# UNITED STATES PATENT AND TRADEMARK OFFICE

APPLICATION NO.	FILING DATE	FIRST NAMED INVENTOR	ATTORNEY DOCKET NO.	CONFIRMATION NO.
09/995,303	11/27/2001	Robert C. Beck	2446	1374

**Office Action Summary**

## DETAILED ACTION

# The Coanda Effect

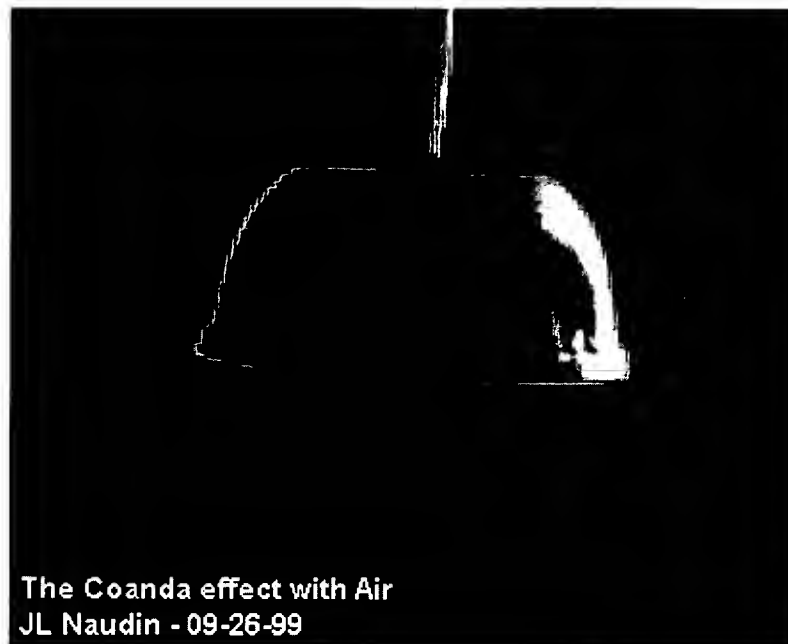
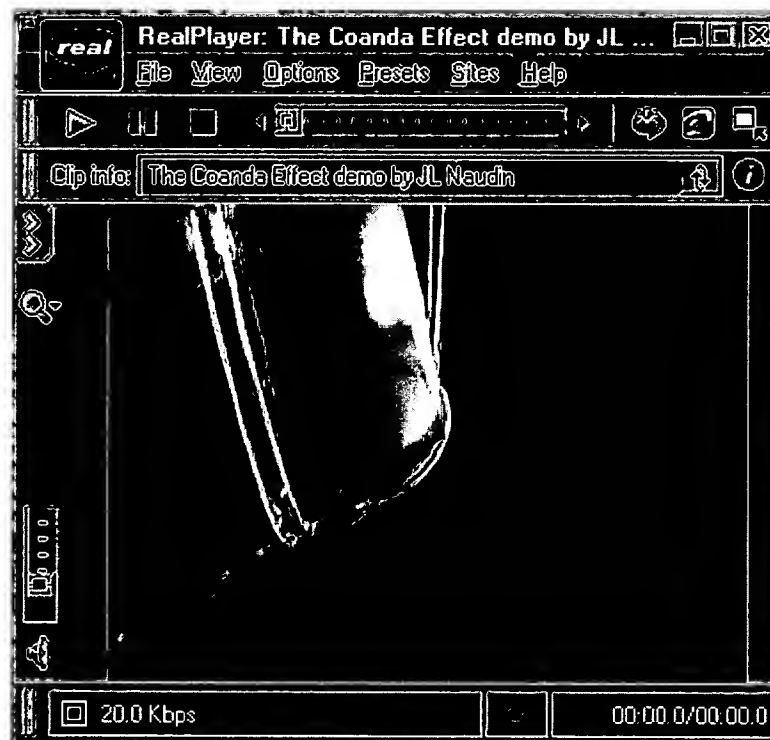
7. With regards to the Coanda effect, the examiner draws the attention of the applicant to <http://jnaudin.free.fr/html/coanda.htm>, which is the website where the examiner determined the definition of the Coanda effect. It seems that any solid surface (with a slight curve) will cause a Coanda effect when a fluid is flowing therethrough. Therefore, the examiner still maintains his rejections of Nash et al. (see figure 3,10, 11) and Fischell et al. (see figure 6) because both references will inherently have a Coanda effect when a stream of fluid is sent through the lumen of the catheters as shown in the figures above.

8. The examiner suggestions adding limitations of the wall attachment or the specific structure that is causing the Coanda effect, since this is the main argument given by the applicant, therefore adding those limitations show expedite prosecution.
